**Re: 575 East Blithedale Avenue (PL20-4916)**

To help the City finalize its analysis of the Project's Planning Commission Hearing on November 8, 2022, we have prepared the following documents that are attached to this letter:

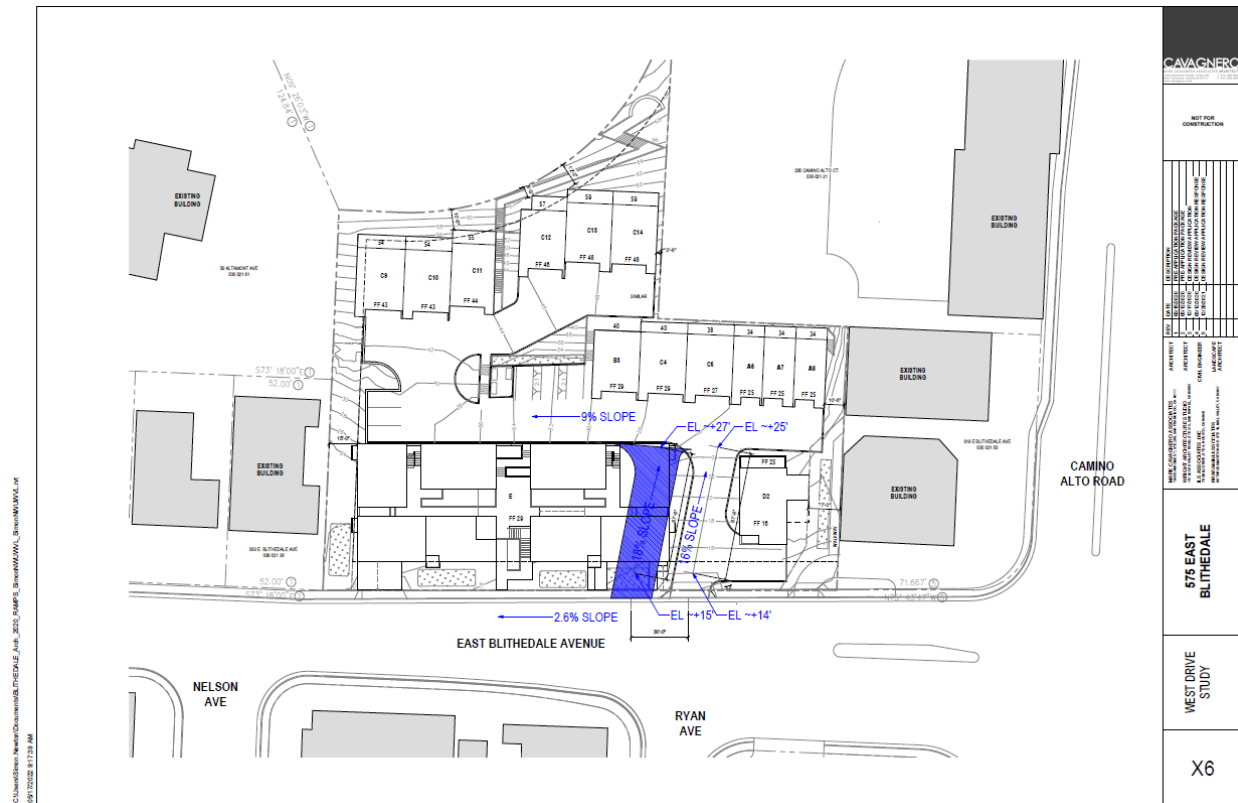
Although not reflected in its written comments, City staff has expressed concern to the Developer that the Project could result in traffic congestion due to vehicles entering or exiting the Project due to the proximity to the East Blithedale Avenue / Camino Alto intersection east of the Project Site, and because of the level of traffic activity that already exists at Ryan Avenue. City staff expressed an interest in relocating the Project’s eastern driveway further west.

Initially, City staff asked if the Project’s eastern driveway could be relocated to the Project Site’s western edge, adjacent to the existing single family home and offset from Nelson Avenue. This offset configuration could cause conflicting traffic movements between vehicles using the driveway and vehicles turning from Nelson Avenue on the East Blithedale, and it would generally be less favored than the proposed design for this reason.

Moreover, the Marin Fire Department allows a maximum allowable drive slope of 18% for properties such as the Project Site. Because the Project Site slopes up sharply as it moves north from East Blithedale Avenue, multiple switchbacks would be required to maintain an 18% grade. The restricting condition is that East Blithedale Avenue slopes at 2.6% as it moves east to west; however the Project site’s mid-site cross drive slopes 9% to reach the elevations where the northern-most townhomes currently sit. In other words, the site’s slope rises at more than 3 times the rate of Blithedale’s slope.

The Project has been designed to maximize its unit count using a shared internal drive aisle from the east; if the Project were designed with access from the west, much more of the site would be devoted to switchbacks, and a loss in unit count would result.

To maintain a relatively straight driveway, as is shown in the current proposed Project, it would only be possible to move the driveway approximately 30' west from where it is currently located. See below:

The alternative would also result in a loss of units, since the driveway would be relocated through the Project's main building. It would also create an offset intersection with Ryan Avenue. As discussed above, off-set intersection conditions are generally less safe and not preferred to aligned four-way intersections.
